APPLICATION NO.	FILING DATE	FIRST NAMED INVENTOR	ATTORNEY DOCKET NO.	CONFIRMATION NO.
10/809,858	03/26/2004	Wilfried Mackel	677/41958	7598

Office Action Summary	Application No.	Applicant(s)	
	10/809,858	MACKEL ET AL.	
	Examiner	Art Unit	
	Charles E. Cooley	1723

NON-FINAL OFFICE ACTION

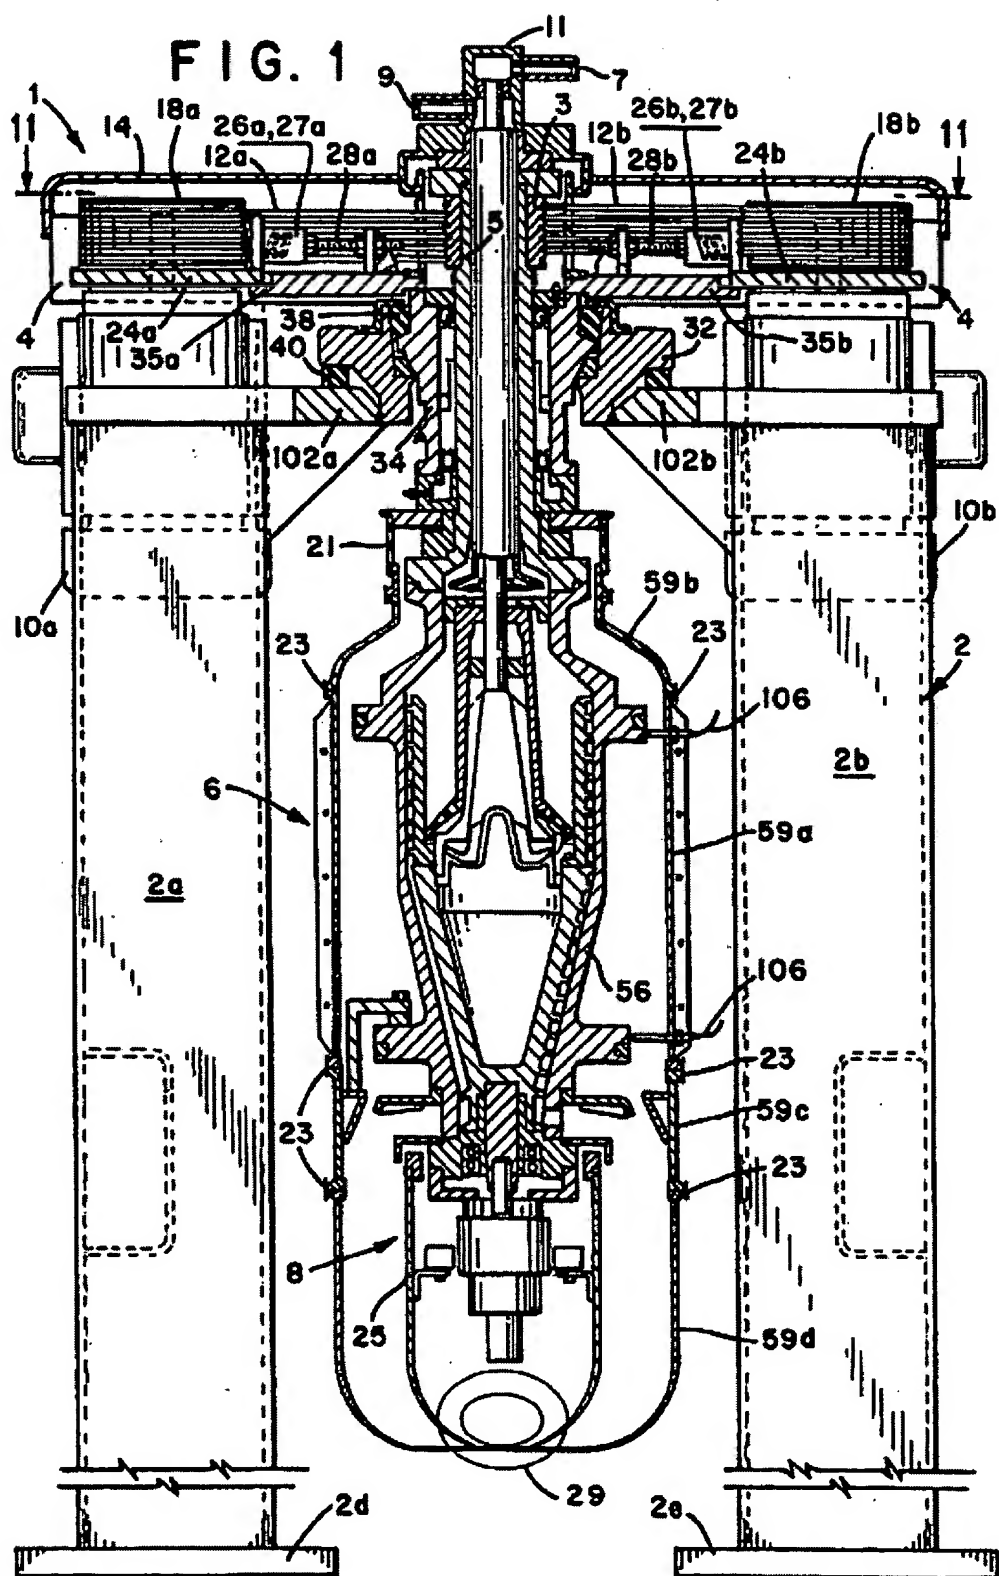
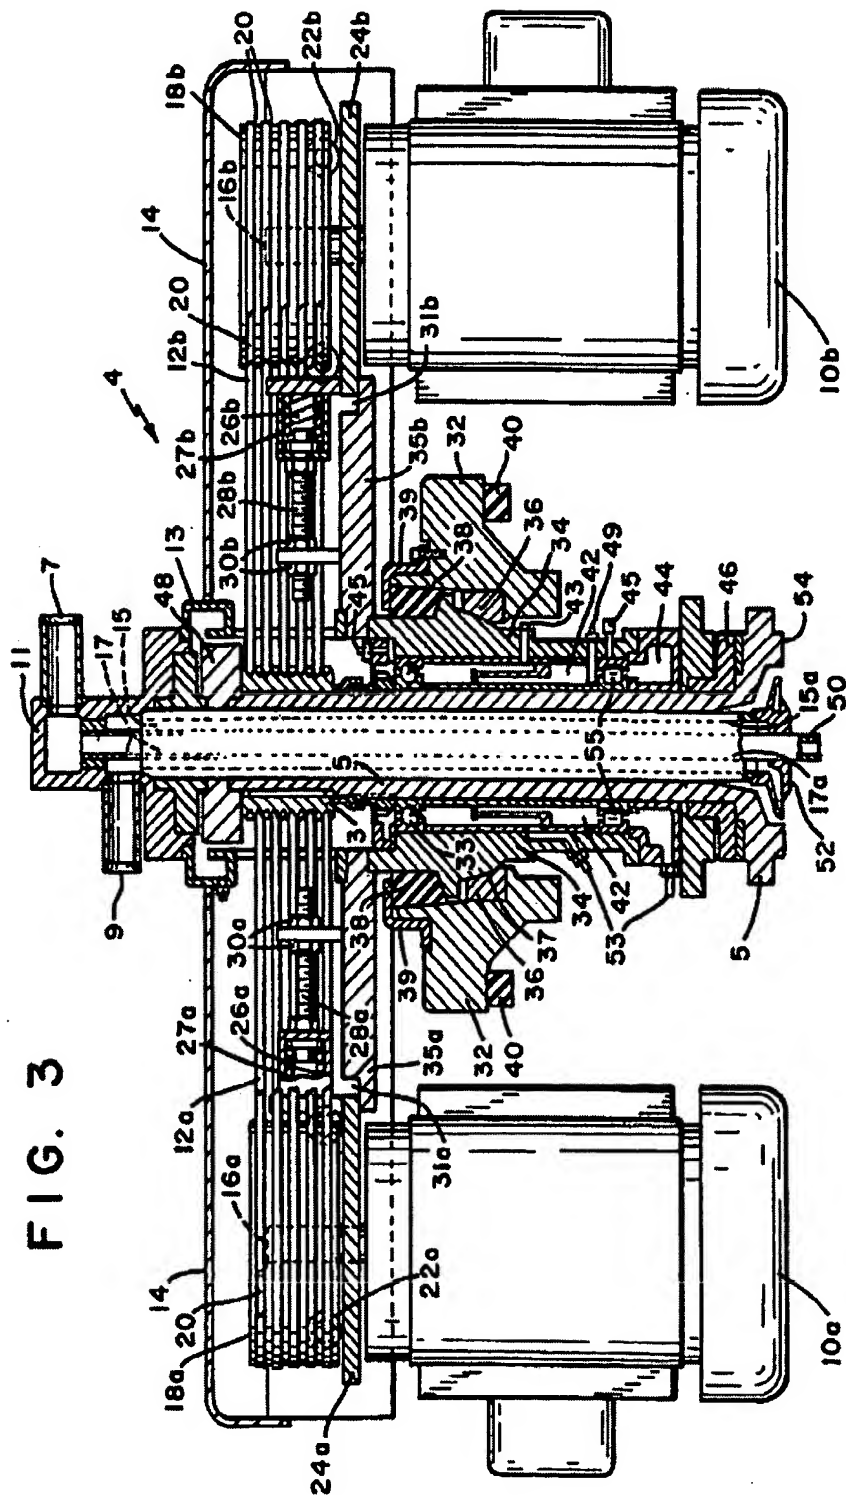
14. Claims 1-3, 5-8, 10-14, and 16 are rejected under 35 U.S.C. 102(b) as being anticipated by Franzen et al. (US 5,364,335).

The patent to Franzen et al. (US 5,364,335) discloses, as seen in the Figures below, a driving system for a separator having a centrifugal drum 56 with a vertical axis of rotation, comprising: a vertically aligned driving spindle 5 configured to accommodate a centrifugal drum 56; the driving spindle being arranged by a neck bearing 33 and a footstep bearing 55 in an opening of a drive housing 32; the neck bearing being 33 supported in an axially rigid and radially resilient manner (via rubber member 38) on the machine housing; and the neck bearing 33 being constructed as an angular ball bearing and supporting the centrifugal drum on a spherical-shaped supporting surface 37 of the machine housing; the neck bearing 33 is supported on an inside in an upward direction on the driving spindle 5 and in a downward direction toward an outside on an outer neck bearing ring 34; the neck bearing 33 includes a neck bearing ring 34 having a ball and socket-type construction on its underside resting on the complementarily spherical-shaped supporting surface 37; the spherical shaped supporting surface 37 is utilized for a weight-dependent frictional damping of the driving system; a gap (in which elements 36 and 38 are disposed) is located between an outer circumference of the neck bearing ring 34 and an inner circumference of the drive housing 32; a sealing and spring ring 38 bridges the gap; the footstep bearing 55 is radially fixed in the drive housing and is axially disposed as a movable bearing; a supporting surface of the neck bearing ring 34 on the drive housing is connected with a lubricating system 42, 49, 53 for lubricating the neck bearing and the footstep bearing; the neck bearing and the footstep bearing are

connected by a duct 42 around the driving spindle 5, so that the two bearings can be jointly lubricated; a first lubricating bore (below 45) for a lubricant, leads into an area around the driving spindle above the neck bearing; a second lubricating bore 49 is provided for guiding lubricant to the footstep bearing; wherein the lubricant is oil (col. 3, lines 46-59).

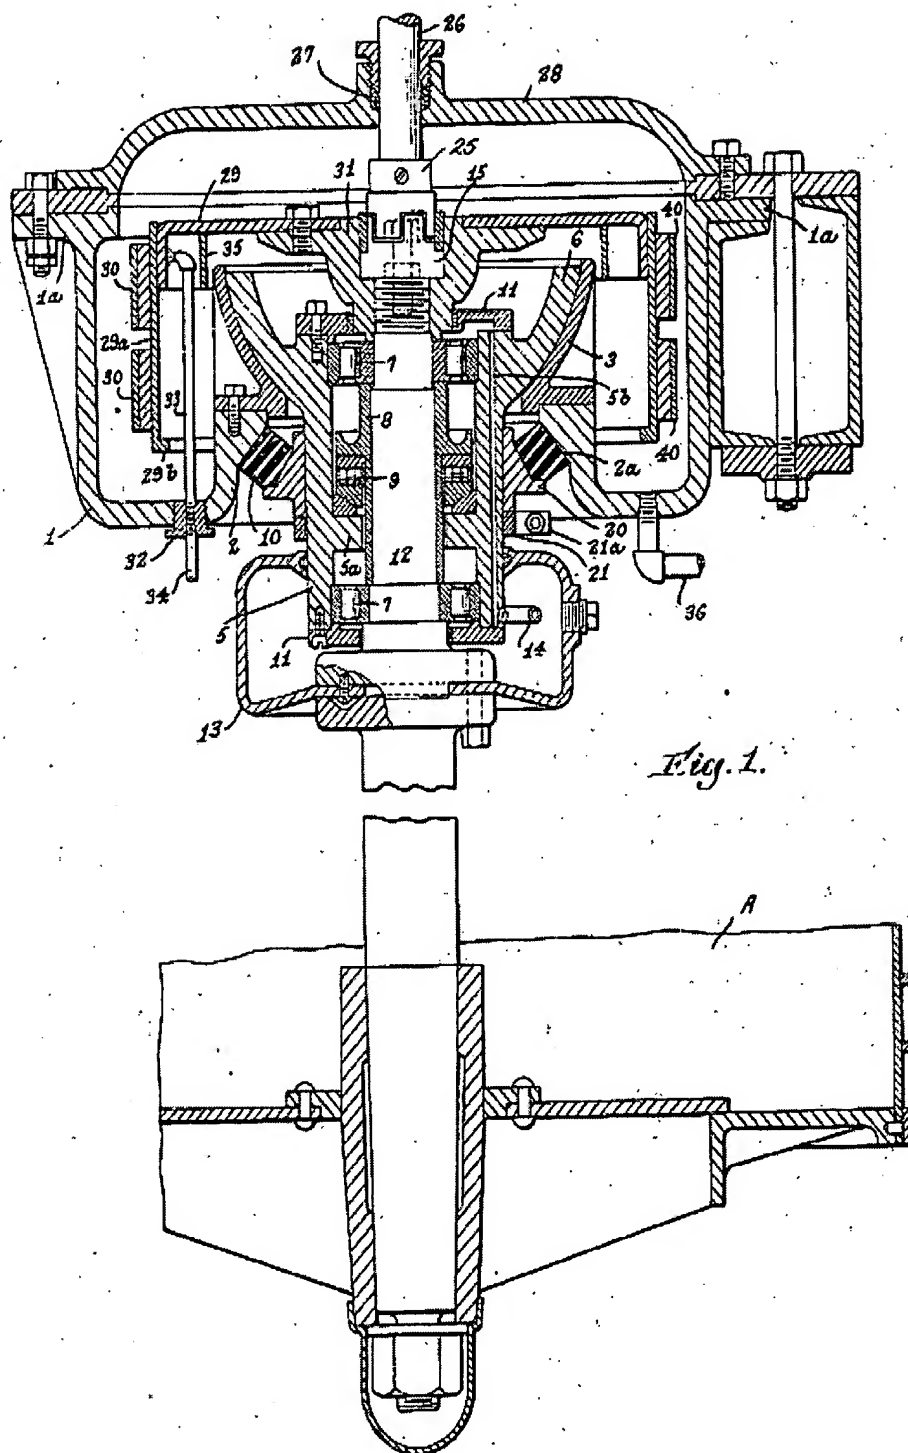
15. Claims 1-3, 5-8, 10-14, and 16 are rejected under 35 U.S.C. 102(b) as being anticipated by Williams (US 2,040,351).

The patent to Williams '351 discloses, as seen in the Figure below, a driving system for a separator having a centrifugal drum A with a vertical axis of rotation, comprising: a vertically aligned driving spindle 12 configured to accommodate a centrifugal drum A; the driving spindle being arranged by a neck bearing (the uppermost bearing 7) and a footstep bearing (9 or the lowermost bearing 7) in an opening of a drive housing 1; the neck bearing being supported in an axially rigid and radially resilient manner (via yielding member 10) on the machine housing; and the neck bearing being constructed as an angular ball bearing and supporting the centrifugal drum on a spherical-shaped supporting surface 3 of the machine housing; the neck bearing is supported on an inside in an upward direction on the driving spindle 12 and in a downward direction toward an outside on an outer neck bearing ring 6; the neck bearing includes a neck bearing ring 6 having a ball and socket-type construction on its underside resting on the complementarily spherical-shaped supporting surface 3; the spherical shaped supporting surface 3 is utilized for a weight-dependent frictional damping of the driving system; a gap (in which element 10 is disposed) is located between an outer circumference of the neck bearing ring 6 and an inner circumference of the drive housing; a sealing and spring ring 10 bridges the gap; the footstep bearing is radially fixed in the drive housing and is axially disposed as a movable bearing; a supporting surface of the neck bearing ring 6 on the drive housing is connected with a lubricating system 5b, 13, 14 for lubricating the neck bearing and the footstep bearing;

the neck bearing and the footstep bearing are connected by a duct 5b around the driving spindle 12 so that the two bearings can be jointly lubricated; a first lubricating bore (below 11) for a lubricant, leads into an area around the driving spindle above the neck bearing; a second lubricating bore (below 5a) is provided for guiding lubricant to the footstep bearing; wherein the lubricant is oil (col. 2, lines 42-49).

FIG. 16

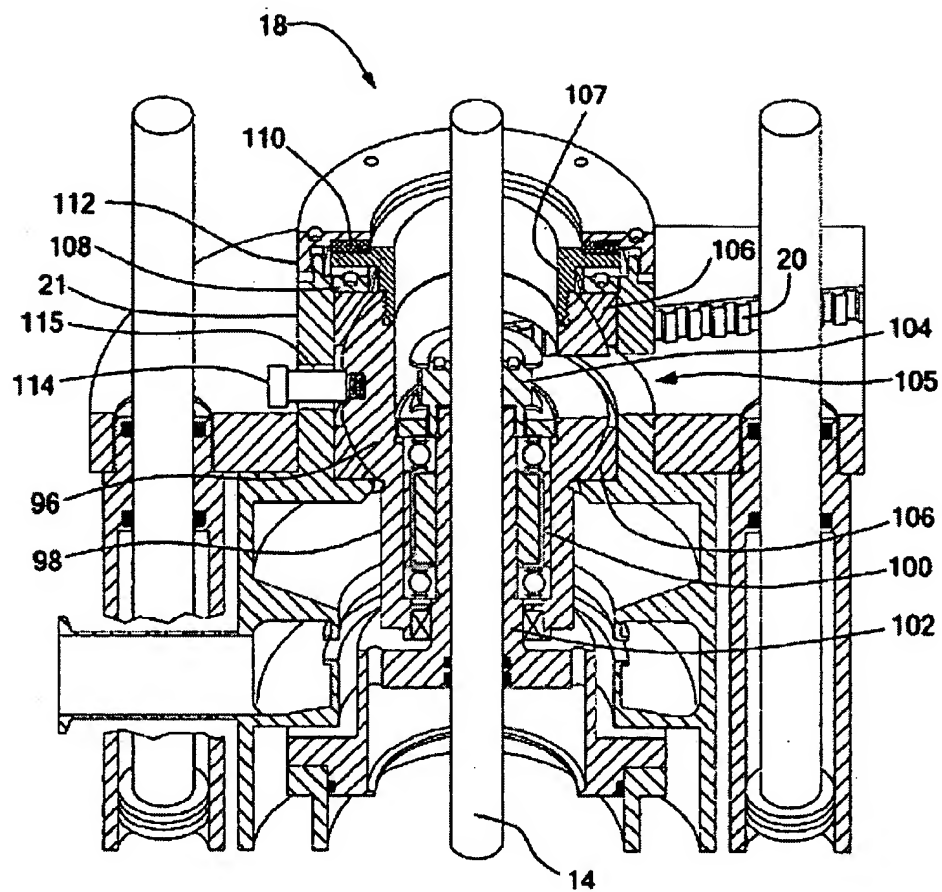
16. Claims 1-3, 5-7, 10, and 12 are rejected under 35 U.S.C. 102(e) as being anticipated by Carr (US 6,776,752 B2).

The patent to Carr '752 discloses, as seen in Figure 16 below, a driving system for a separator having a centrifugal drum 10 with a vertical axis of rotation, comprising: a vertically aligned driving spindle 14 configured to accommodate a centrifugal drum 10; the driving spindle being arranged by a neck bearing (below 104) and a footstep bearing (above 102) in an opening of a drive housing 21; the neck bearing being supported in an axially rigid and radially resilient manner (via yielding member 110) on the machine housing; and the neck bearing being constructed as an angular ball bearing and supporting the centrifugal drum on a spherical-shaped supporting surface 106 of the machine housing; the neck bearing is supported on an inside in an upward direction on the driving spindle 14 and in a downward direction toward an outside on an outer neck bearing ring 96; the neck bearing includes a neck bearing ring 96 having a ball and socket-type construction on its underside resting on the complementarily spherical-shaped supporting surface 106; the spherical shaped supporting surface 106 is utilized for a weight-dependent frictional damping of the driving system; a gap 105 is located between an outer circumference of the neck bearing ring 96 and an inner circumference of the drive housing; the footstep bearing is radially fixed in the drive housing and is axially disposed as a movable bearing; the neck bearing and the footstep bearing are connected by a duct (within 100) around the driving spindle, which is capable of holding lubricant so that the two bearings can be jointly lubricated.
